RESPONSE BY FRANK LAURICELLA - ARCHITECT 504 650-5617

RE: Permit 22-18538-NEWC New Construction at 1742-1744 Egania St

3-BEDROOM RESIDENCE-CONTAINERS
EGANIA STREET NEW ORLEANS, LOUISIANA

SIDE VIEW

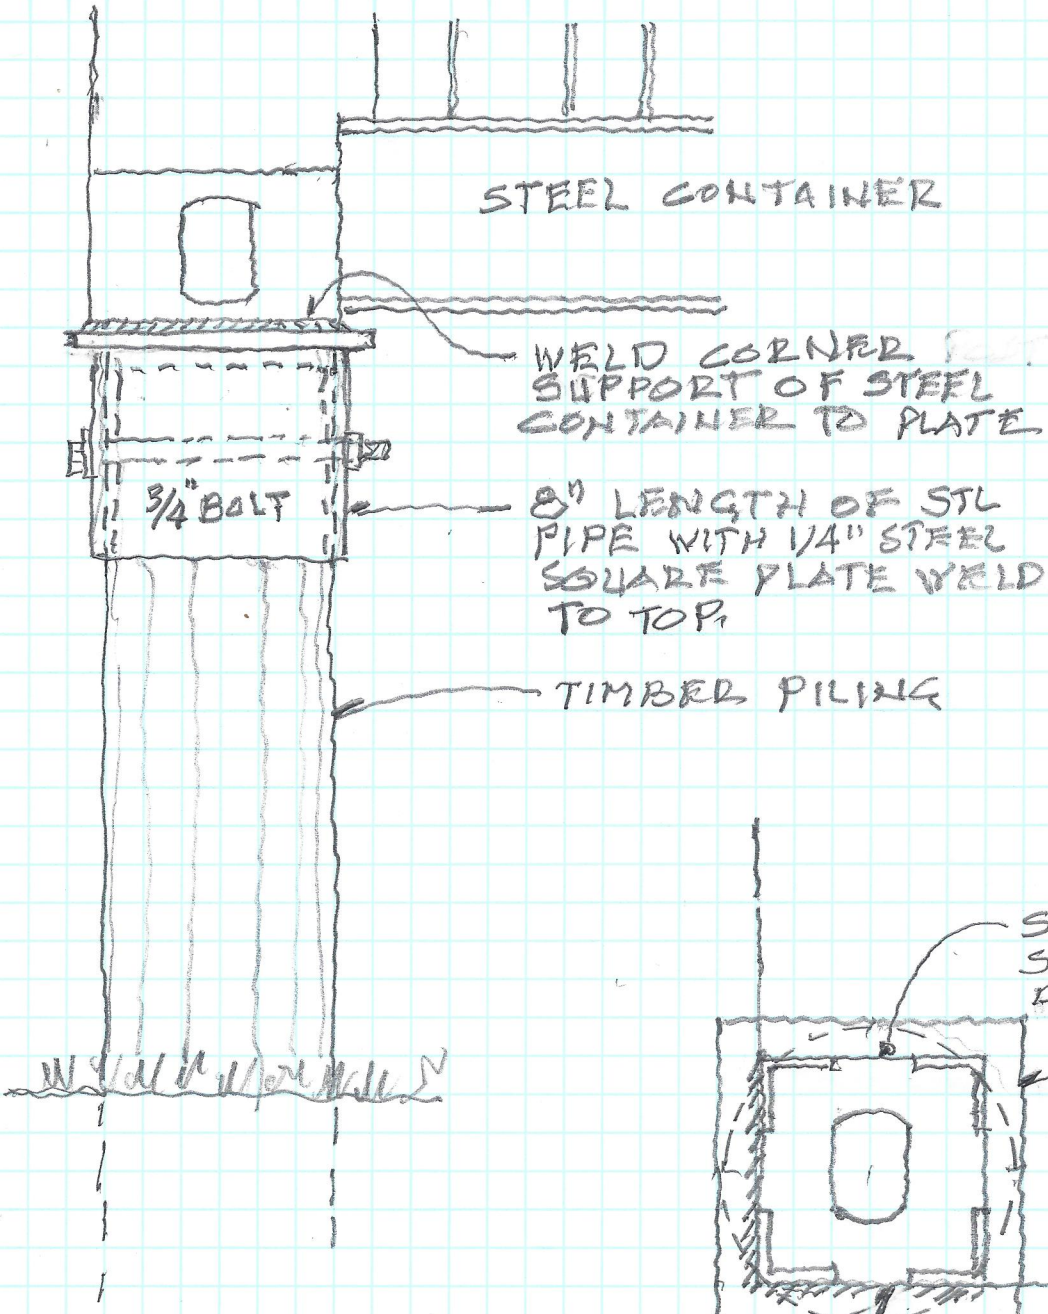
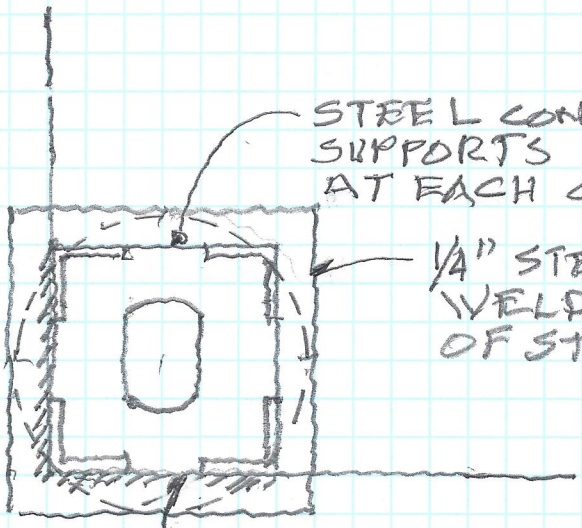
Please provide detail of how container is strapped to timber piers and girders

ATTACHED IS A SKETCH DETAILING THE HOLD-DOWN STEEL COLLARS BOLTED TO EACH PILING AT THE CONTAINER CORNERS. THE COLLARS ARE THROUGH-BOLTED TO THE PILING AND THE CONTAINER'S CORNER LOAD-POINTS ARE WELDED TO THE STEEL TOP PLATE.

SIDE ELEVATION
SCAIE 1/4" = 1'-0"

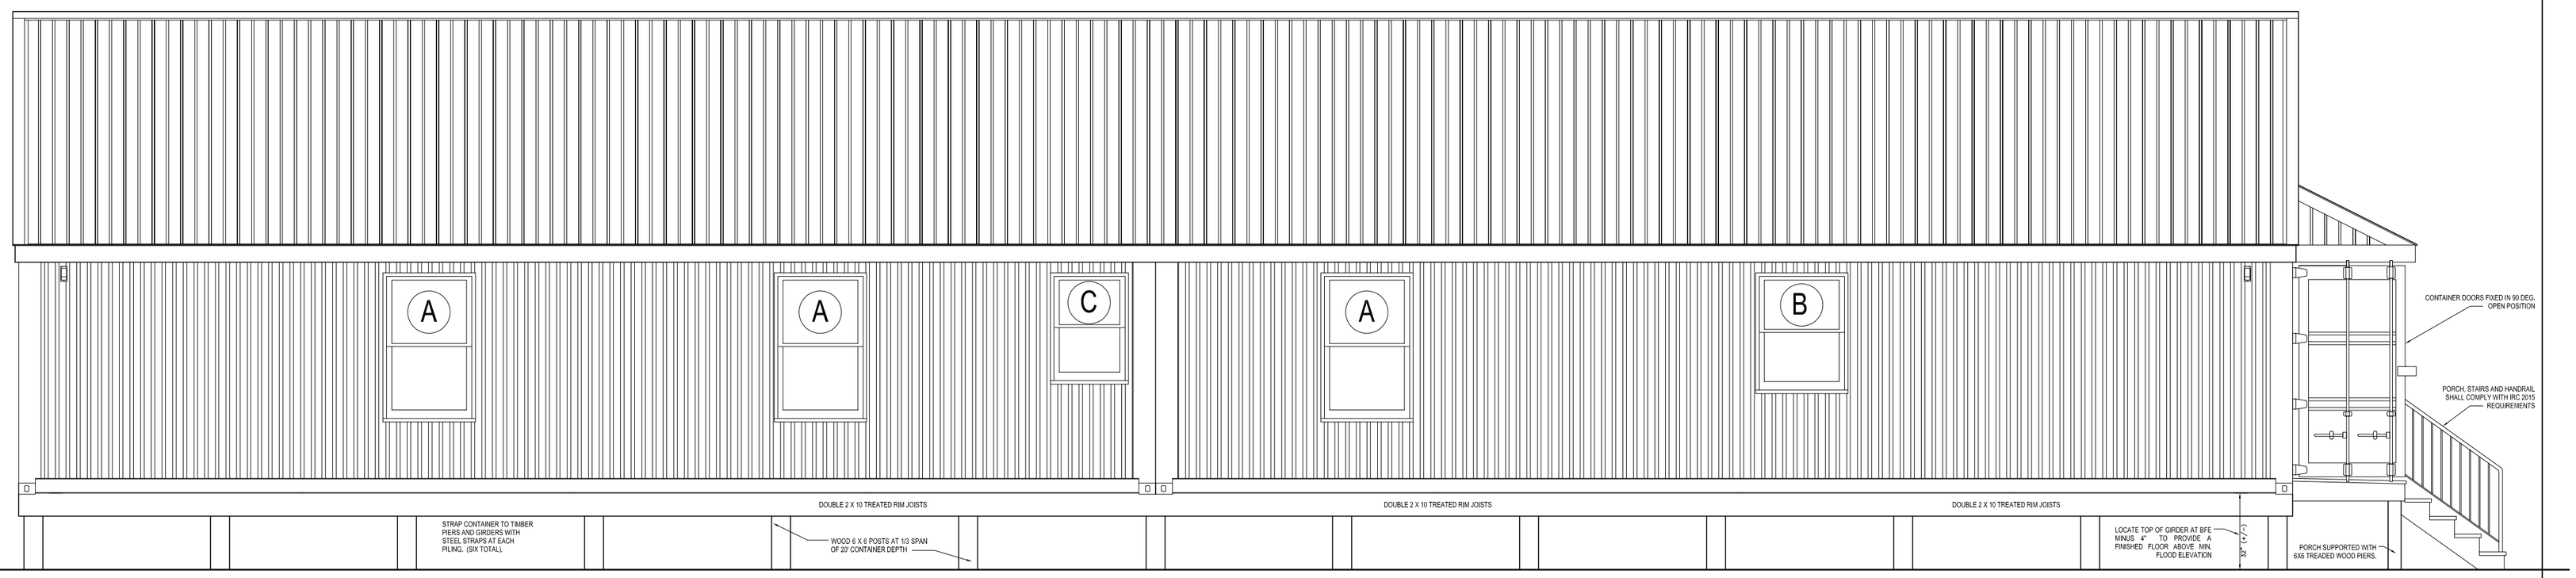
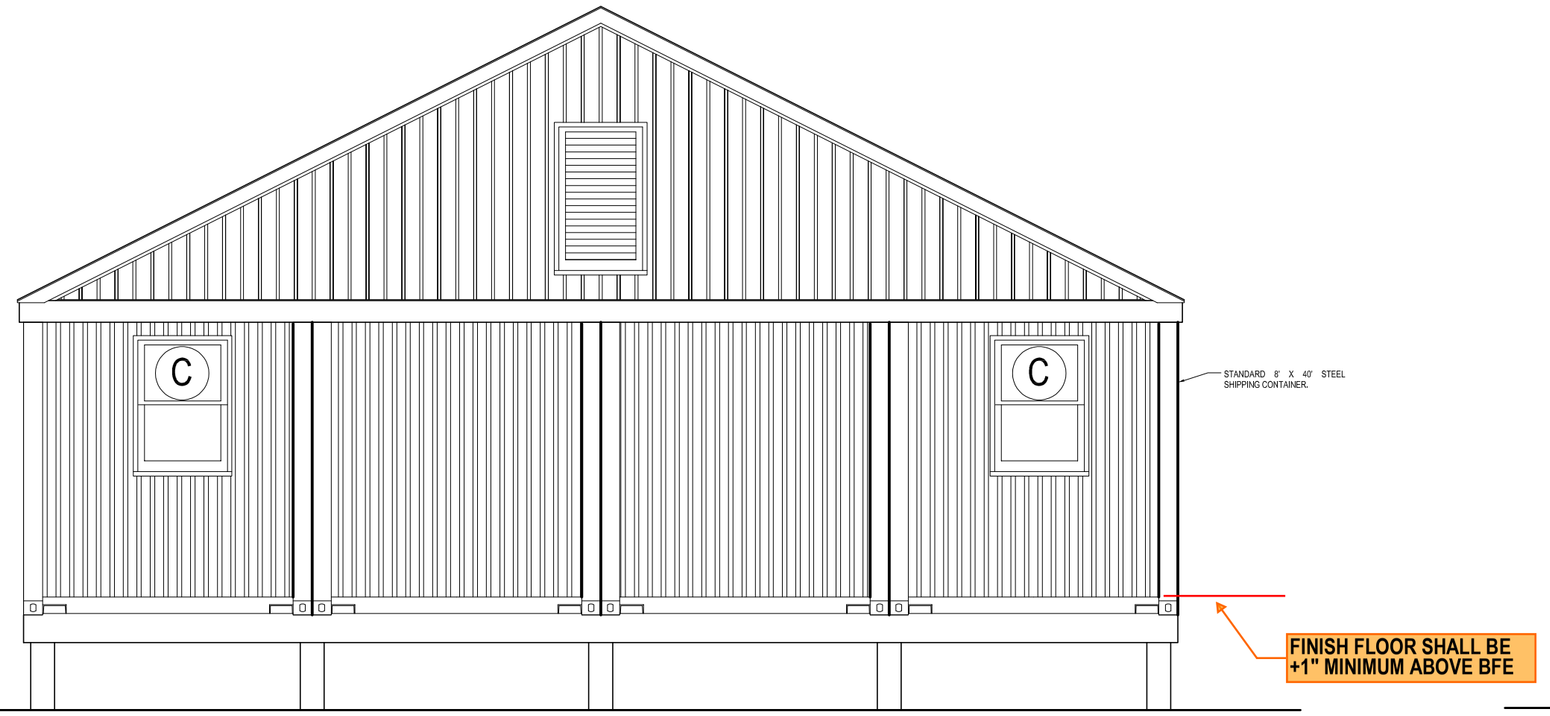
Please mark BFE on elevation drawing

BFE AS SHOWN ON CERTIFICATE IS REFLECTED ON ELEVATION INDICATING THAT FINISHED FLOOR IS 1" MINIMUM ABOVE BFE.
